ADDENDUM

ADDENDUM NO. 3

RE: New Bedford Marine Commerce Terminal
Phase 3 Bulkhead Replacement (Site 4)
Massachusetts Clean Energy Technology Center
Contract No. MACEC-FY26-02

**MAIN
TERMINAL
TO SHUSTER
DETAILS**

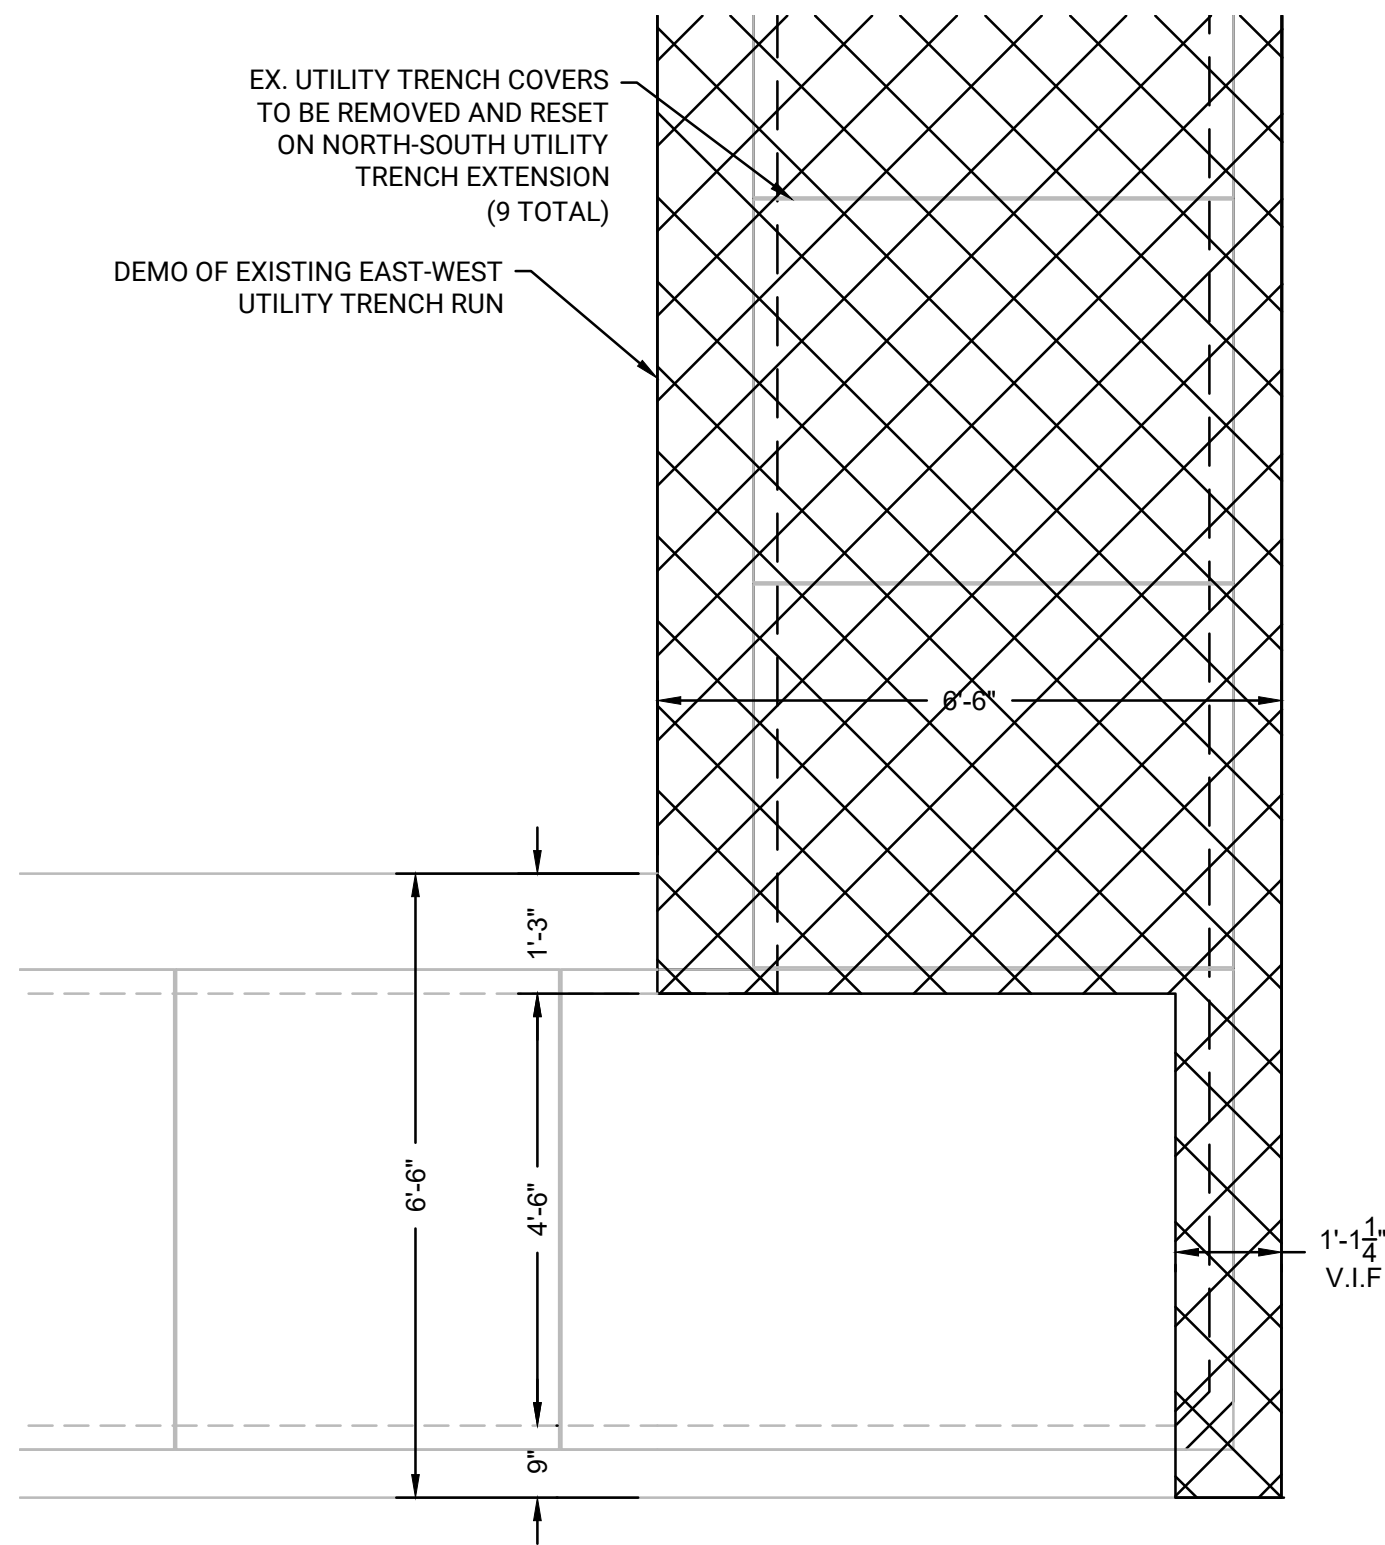
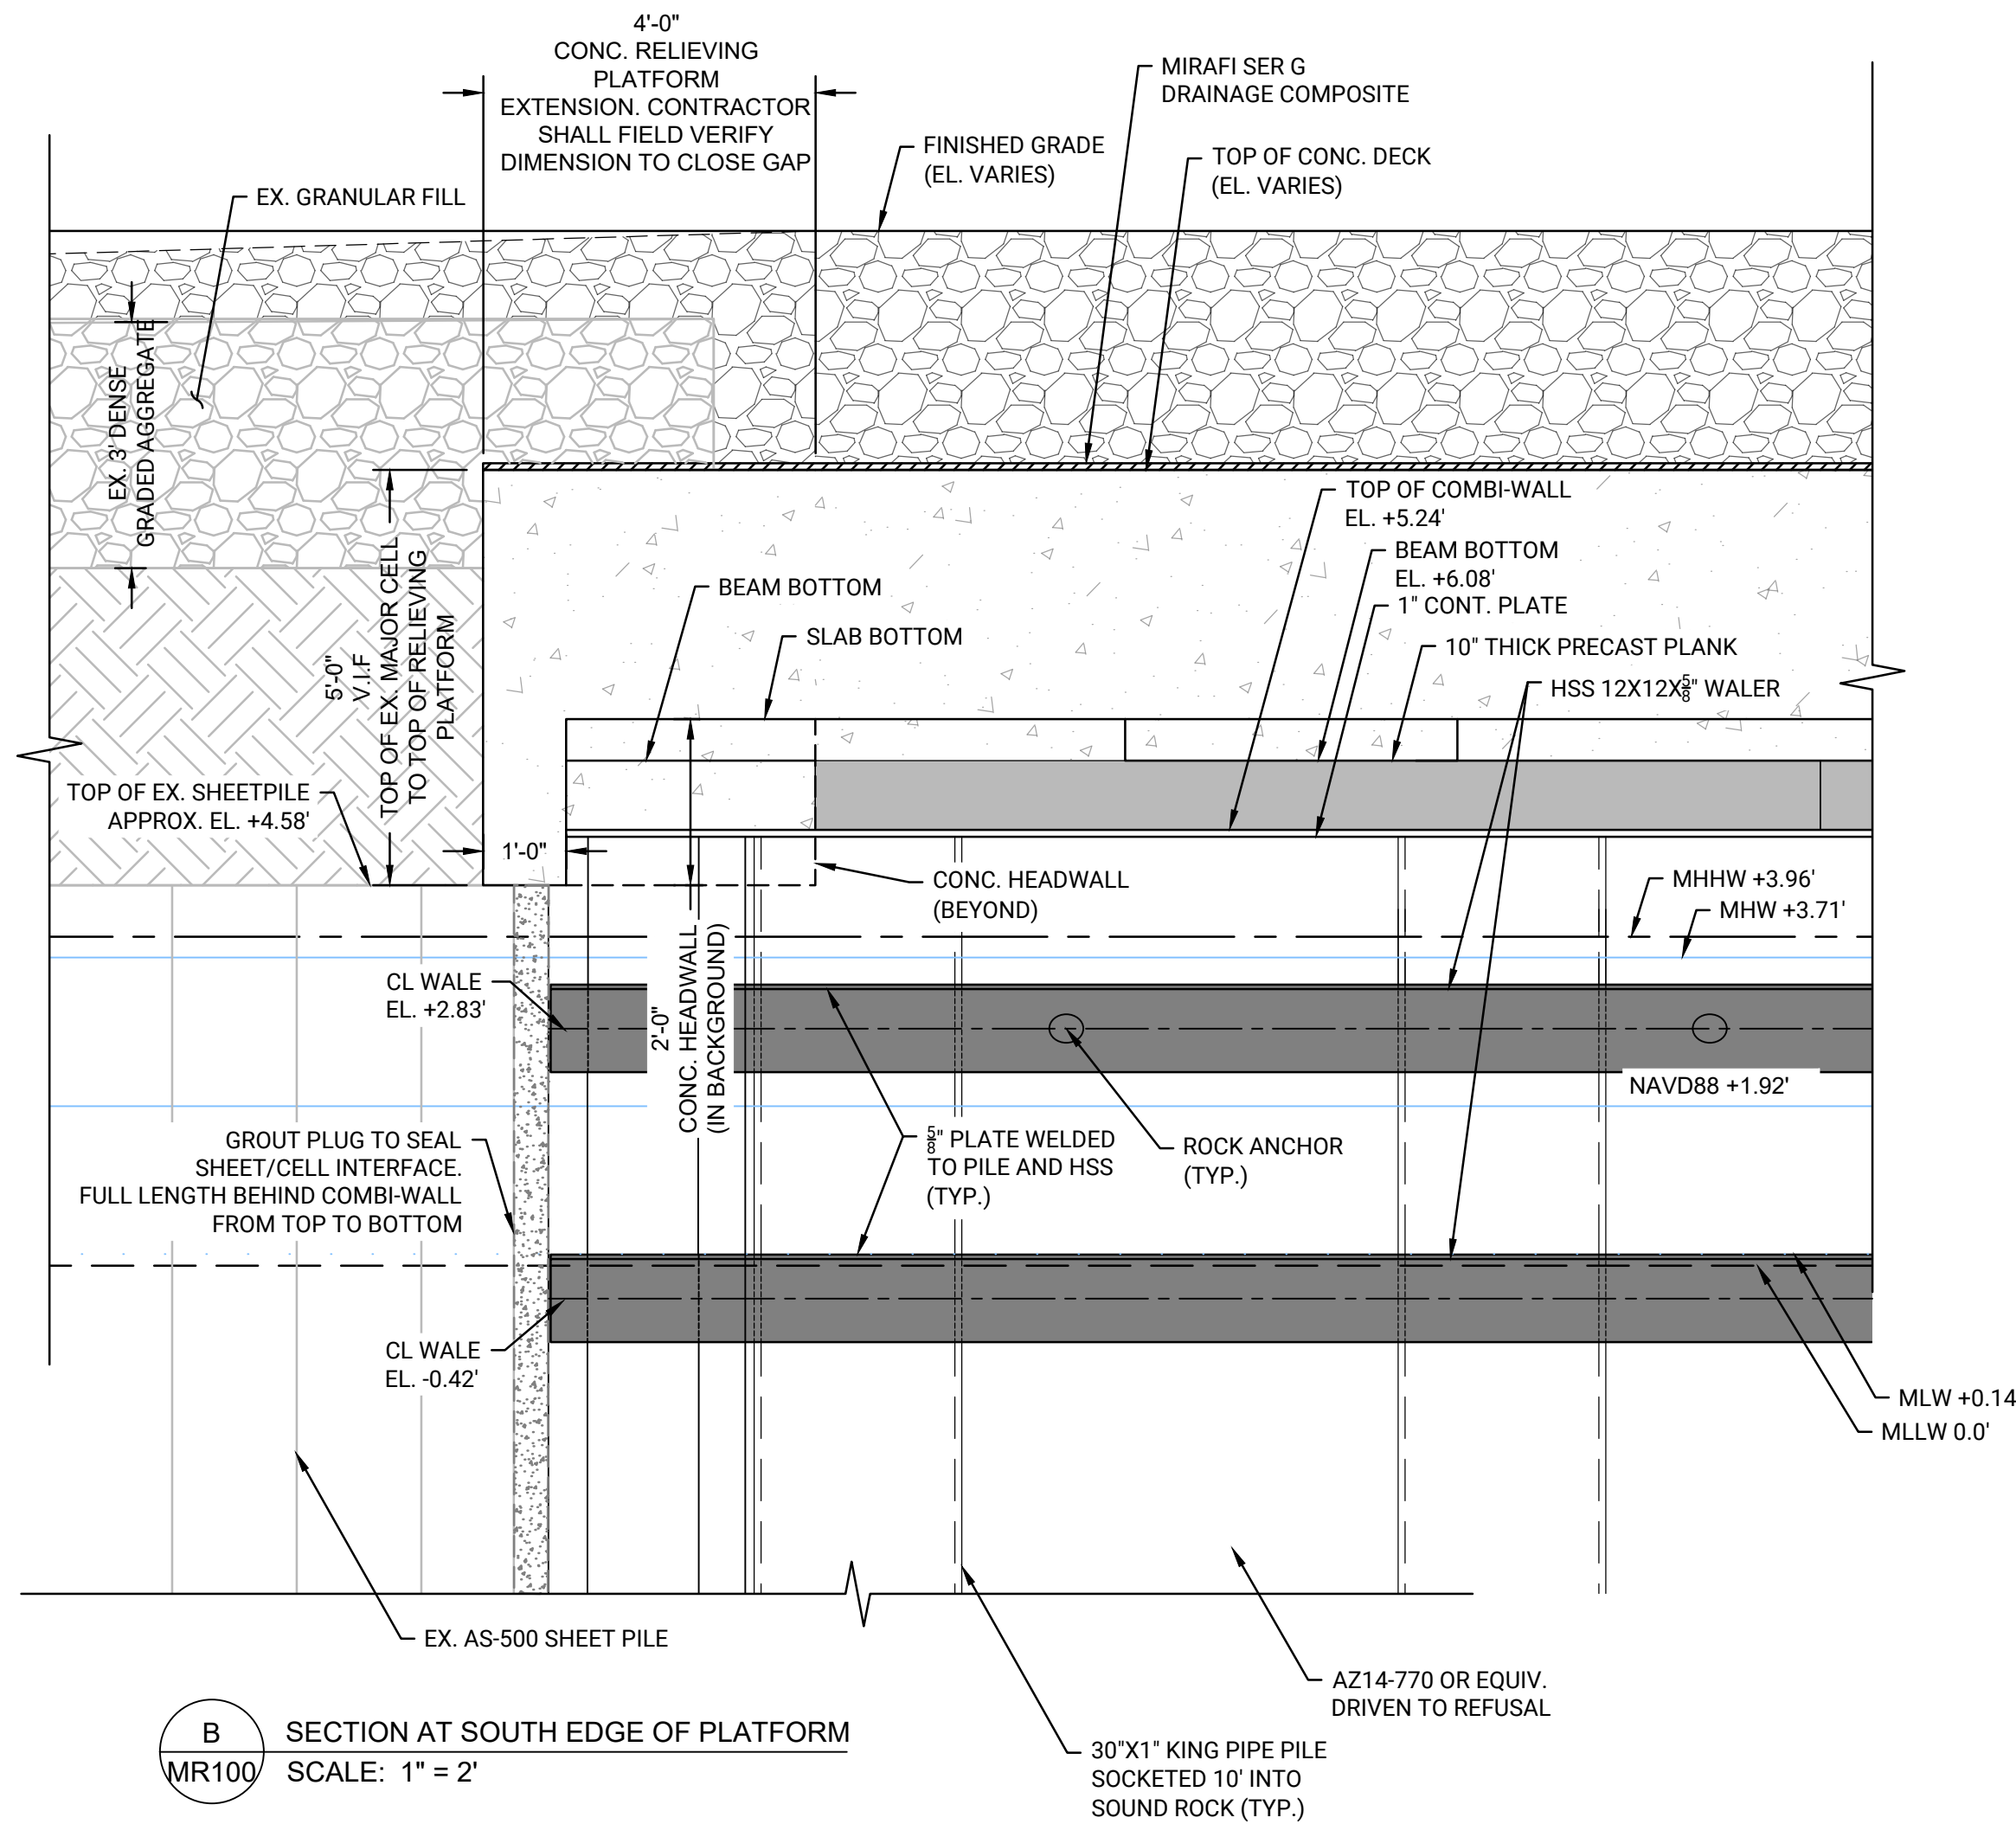
3. Drawings MR100 and MR515 have been revised to reflect structural revisions addressing Question #3 (below). The revised Drawings are provided in **Attachment 1** to this Addendum No. 3.

1. Q: Will spiral weld pipe be acceptable?
A: YES, spiral weld pipe will be allowable steel pipe pile product.
2. Q: Are Pile Caps PC-1 to PC-8 connected to each other? If so, please provide a connections detail.
A: Please refer to the revised Drawings MR102 and MR508 through MR511, and the new Drawing MR511A. PC-1 through PC-6 have been resized and detailed to address precast pile cap connections.
3. Q: Please refer to the snapshot below from MR017. The red hatched area represents a gap between the proposed platform slab and existing Cofferdam cell which will be exposed to the open water below. Please provide a closure detail between the proposed platform slab and Cofferdam Cell to close this space.

- A: The red hatched area will be covered through an extension of the portion of the new platform beams and slabs with concrete headwall. The location and size of the extension is shown on the revised Drawings MR100 and MR515 in **Attachment 1**. All associated work shall be included in Bid Item #38.
